Service Letter No. 310

SUBJECT: Locking of Landing Gear Motor Release Arm

MODELS AFFECTED: PA-24 and PA-24 "250"
Serial Numbers 24-1 to 24-504 inclusive

GEAR MOTOR RELEASE HANDLE
STRAP INSTALLATION

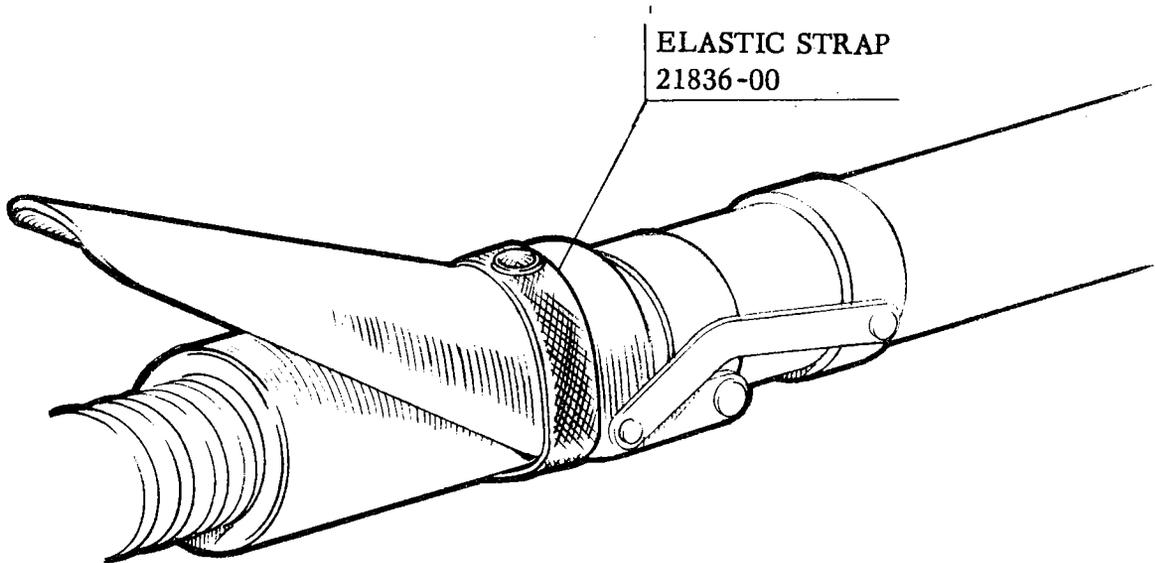
The safety wire used to hold the landing gear retraction motor release arm in a closed position shall be replaced on the above mentioned airplanes by an elastic strap, part number 21836-00, per sketch on the reverse side of this letter.

ELASTIC STRAP
21836-00
